APPENDIX H

AGENCY CORRESPONDENCE

SD100 - CORRIDOR PRESERVATION

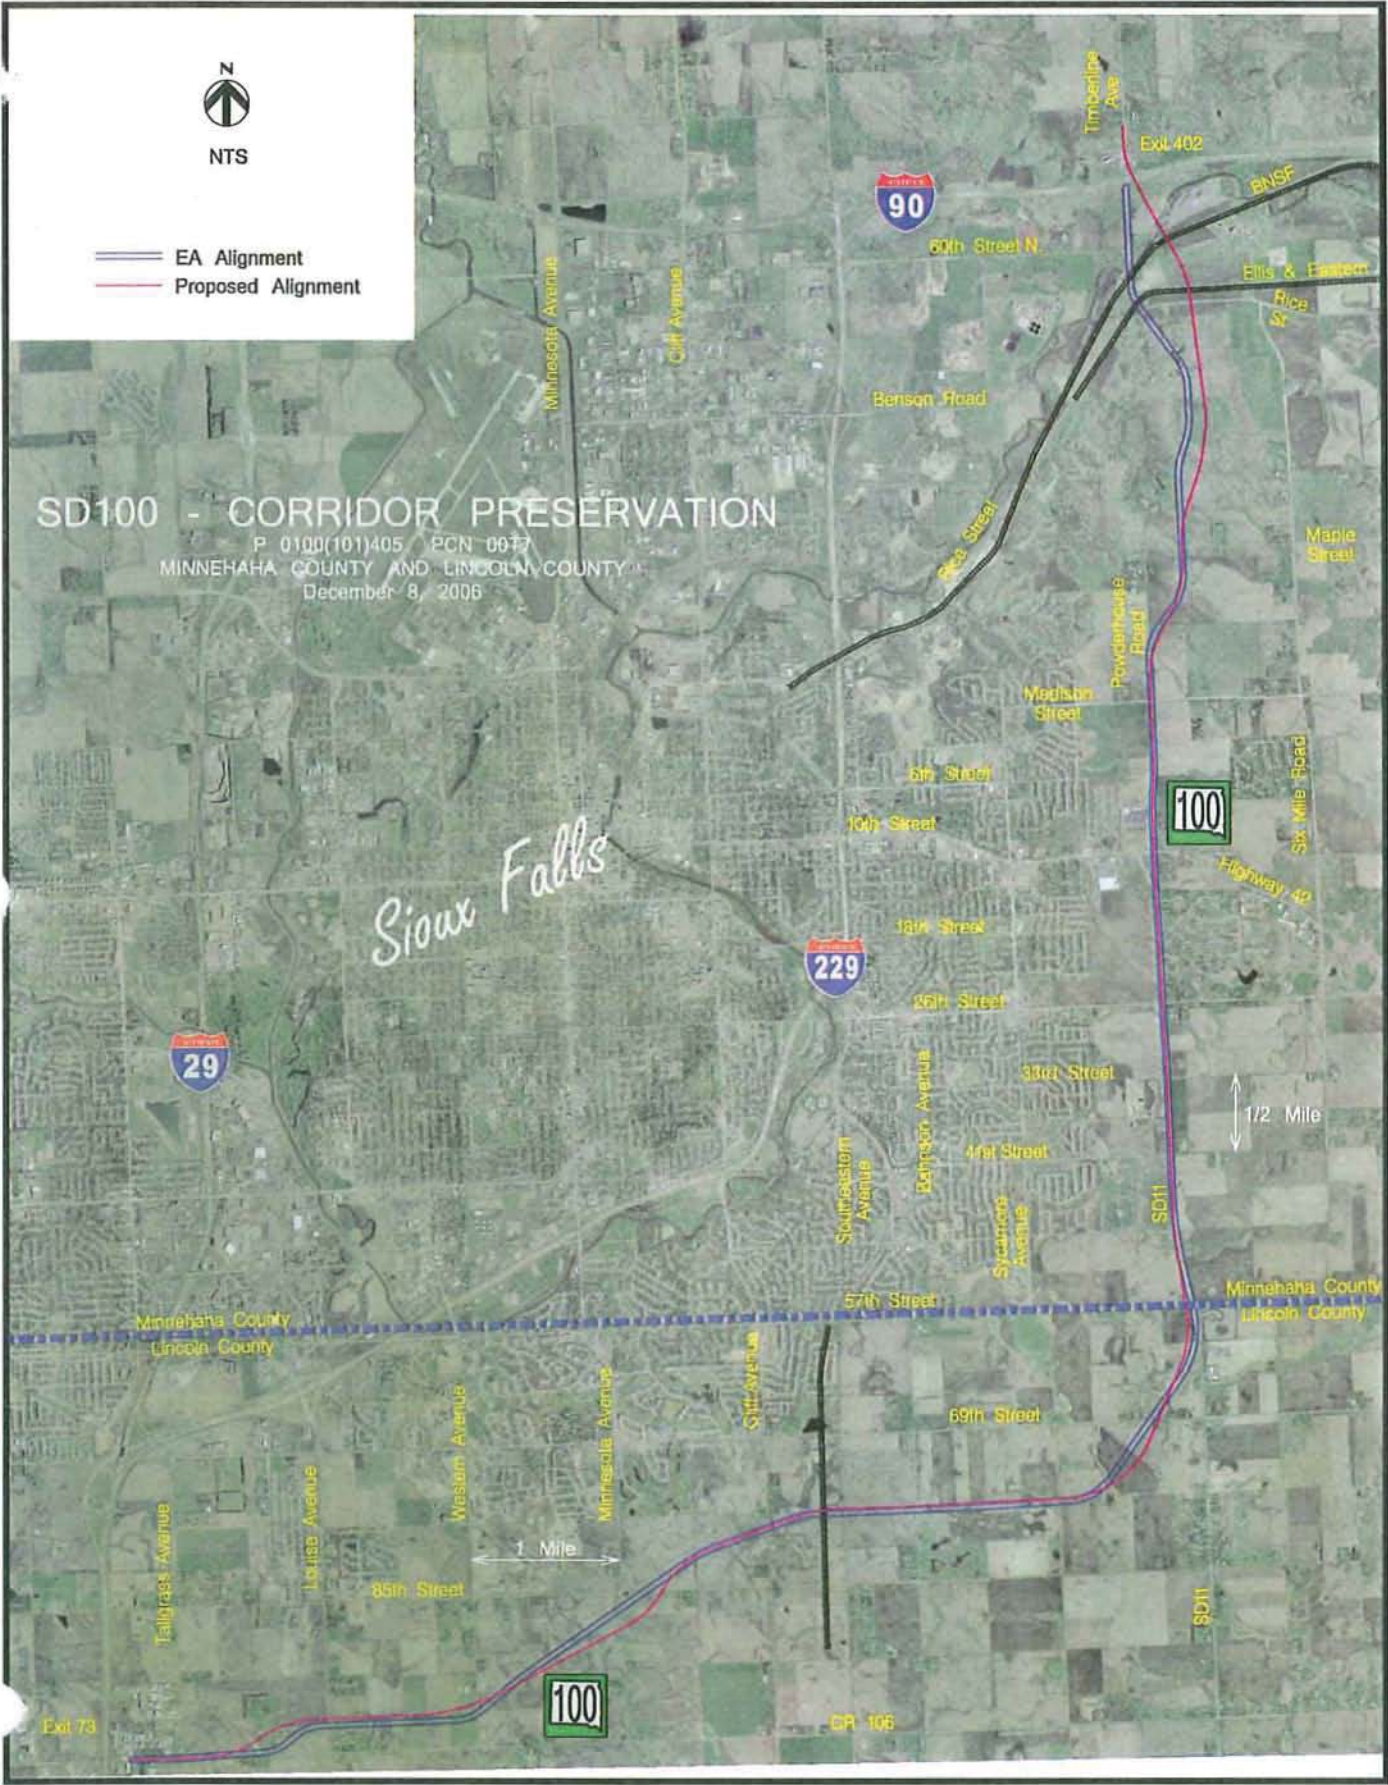
Comparison of National Wetlands Inventory maps with the single small map provided in your letter reveals that numerous wetlands may be impacted by the proposed new alignment that are currently avoided by the current alignment. A complete tally of impacted acres is not provided in your letter to clarify which proposed alignment would result in fewer wetland impacts. As indicated in previous letters from this office regarding this project, if a project may impact wetlands or other important fish and wildlife habitats, the Service, in accordance with the National Environmental Policy Act of 1969 (42 U.S.C. 4321-4347) and other environmental laws and rules, recommends complete avoidance of these areas, if possible; then minimization of any adverse impacts; and finally, replacement of any lost acres; in that order. Alternatives should be examined and the least damaging practical alternative selected. If wetland impacts are unavoidable, a mitigation plan addressing the number and types of wetland acres to be impacted and the methods of replacement should be prepared and submitted to the resource agencies for review.

Figure 3-6

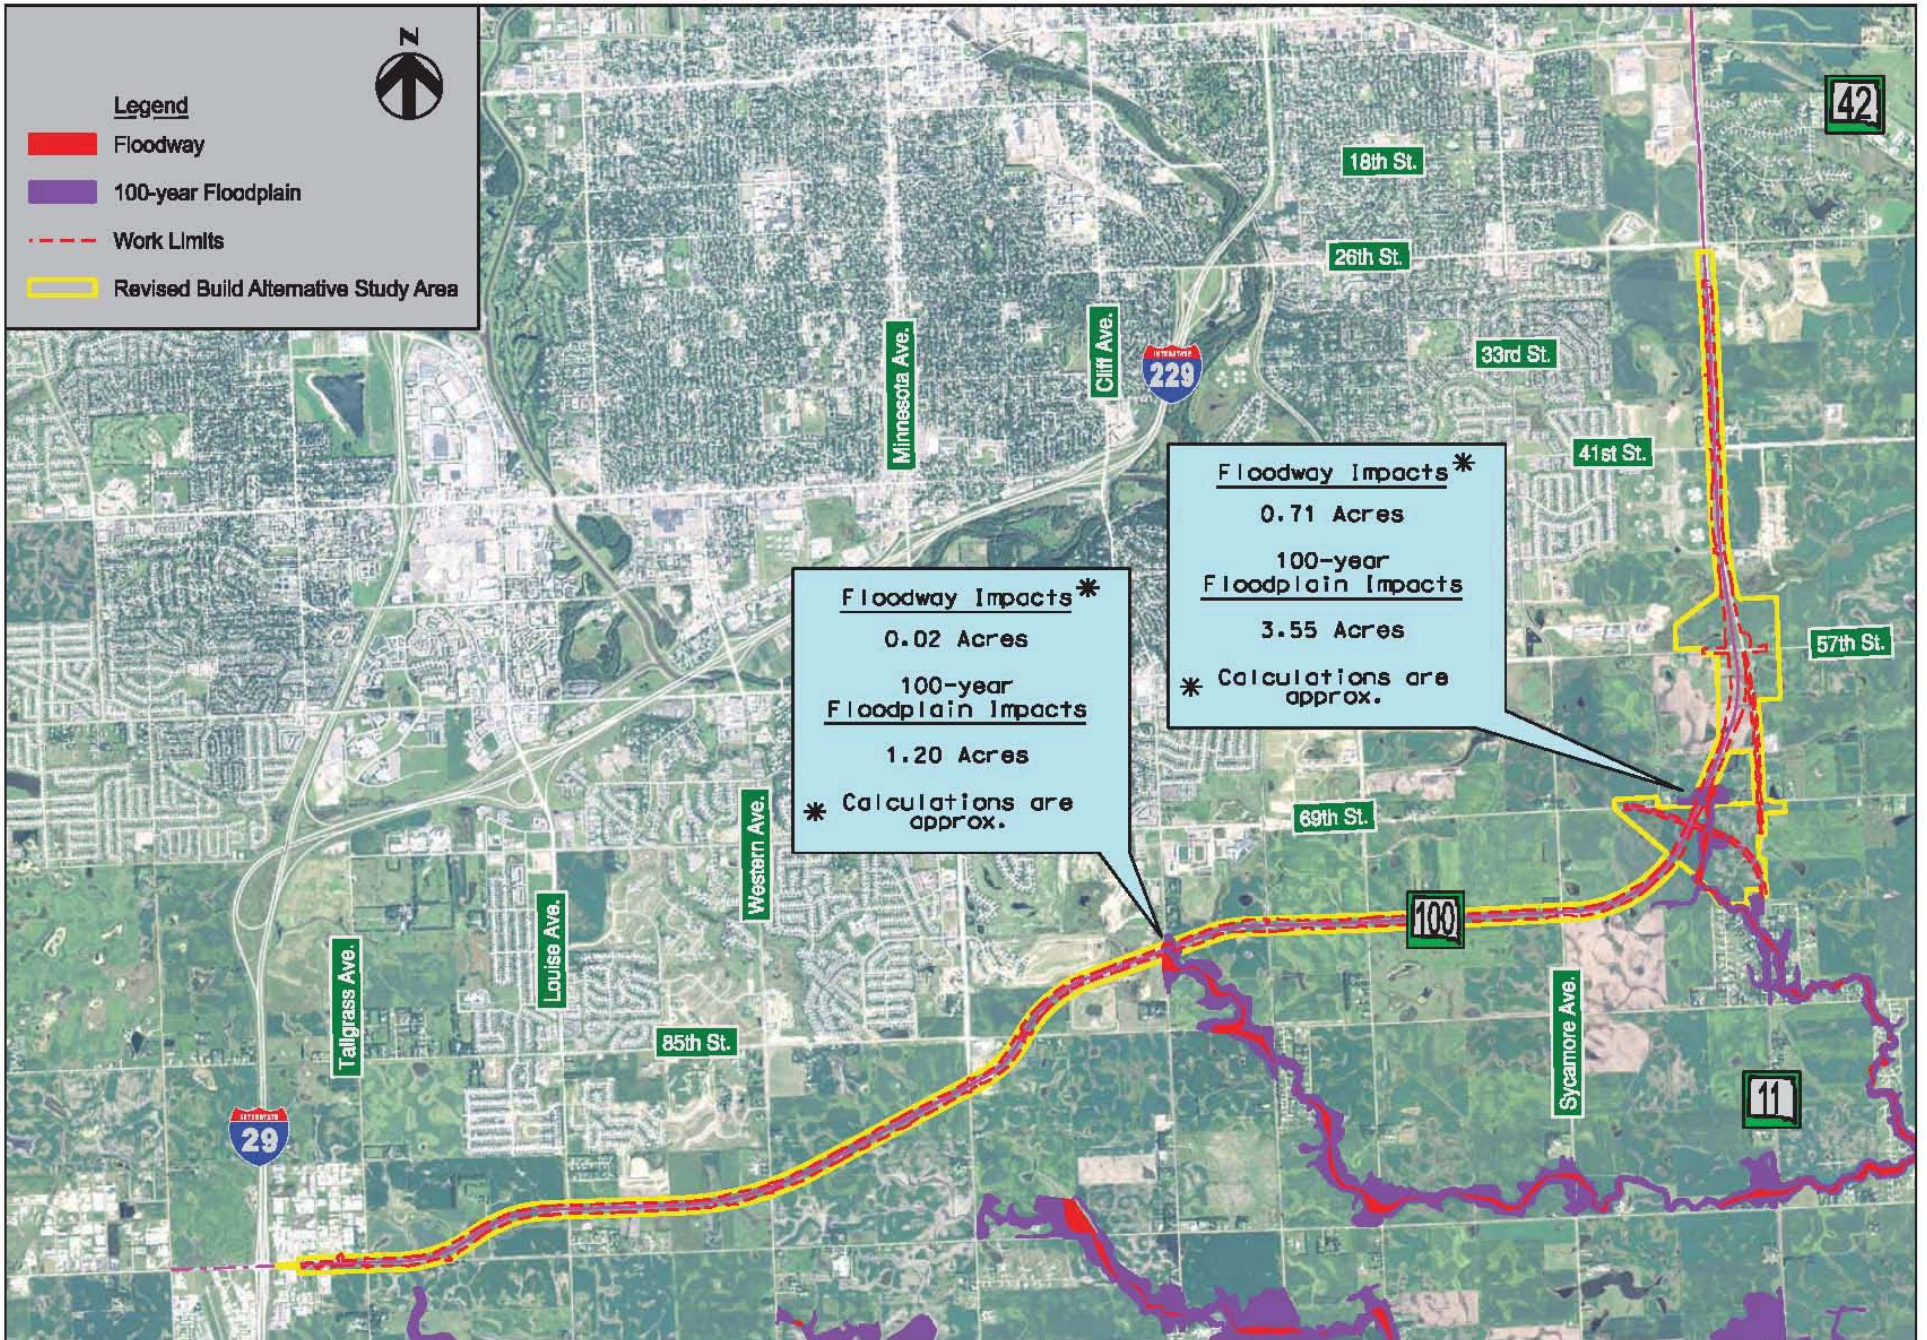
The current designated floodplains within the Southern Segment Study Area are shown on Figure 3-6 which is included in the Draft Supplemental EA. The floodplain identified is associated with Spring Creek and its intermittent tributaries which flow southeast and eventually into the Big Sioux River. The designated floodplain for Nine Mile Creek, Skunk Creek, and Willow Creek is not within the Study Area.

We are requesting your response to verify the designated floodplain in the Study Area of the Supplemental EA, please see Figure 3-6 for the entire Study Area. Please feel free to give me a call with any questions at 605-773-3180.
